HISTORIC AND DESIGN REVIEW COMMISSION

HDRC CASE NO: 2020-207
ADDRESS: 126 CAMARGO
LEGAL DESCRIPTION: NCB 923 BLK 4 LOT 5 & W 27.8FT OF 6
ZONING: RM-4,H
CITY COUNCIL DIST.: 1
DISTRICT: Lavaca Historic District
APPLICANT: Robert Alvarado/South Antonio Builders
OWNER: Kathryn Ruckman/BEANVILLE BUNGALOWS LLC
TYPE OF WORK: Exterior alterations, site modifications
APPLICATION RECEIVED: May 15, 2020
60-DAY REVIEW: Not applicable due to City Council Emergency Orders
CASE MANAGER: Stephanie Phillips

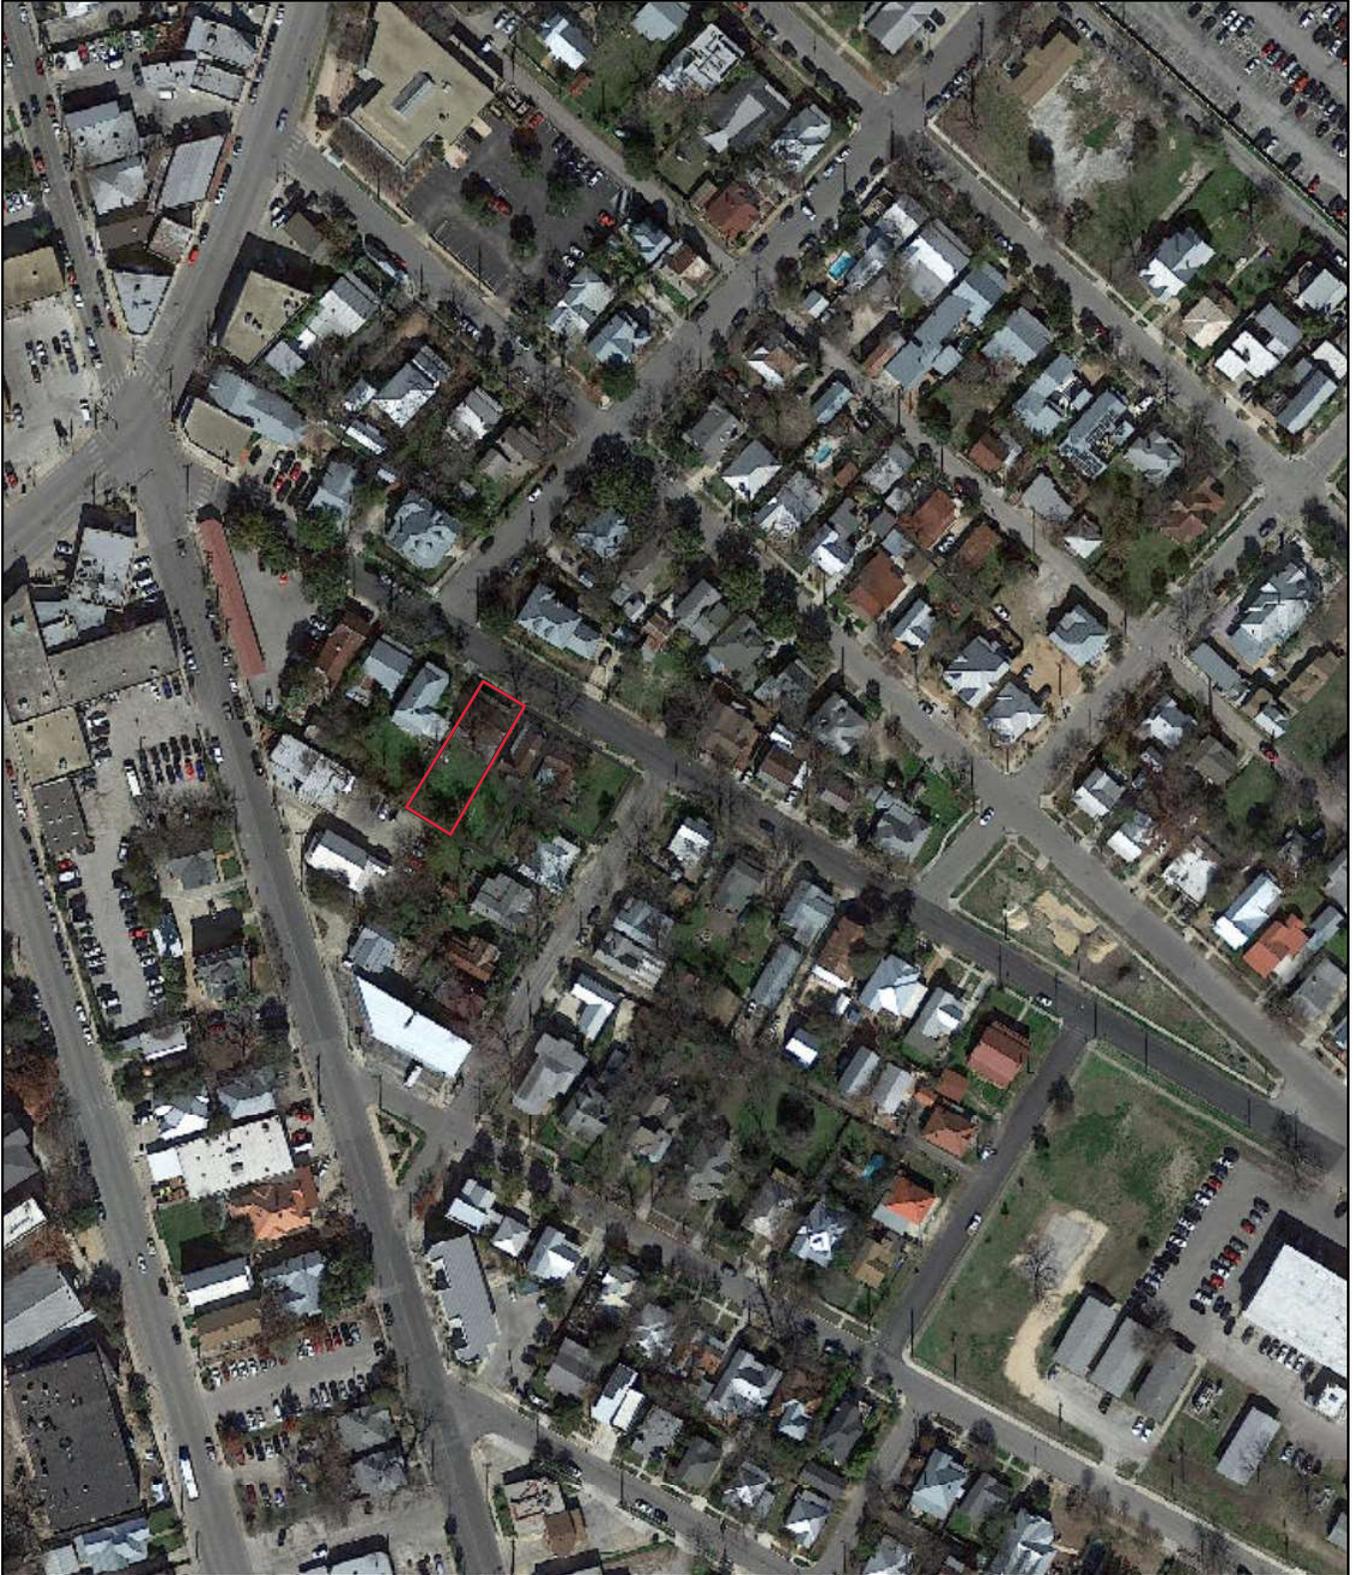
- g. **CHIMNEY** – Based on the submitted elevations, the applicant has proposed to construct a new side brick chimney. The chimney is not indicated on the site plan, and only two elevations have been provided. The front elevation indicates that the chimney will be located on the east elevation, however the submitted east elevation indicates that the chimney will be on the west. The drawings also show a discrepancy in both form and height of

the chimney, and reveal that existing opening modifications may need to be altered or removed to accommodate the chimney. While staff finds that a new chimney may be appropriate for the structure, staff finds that not enough information has been provided at this time to make a determination or recommendation.

Item 6, Staff does not recommend approval of the chimney at this time based on finding g.
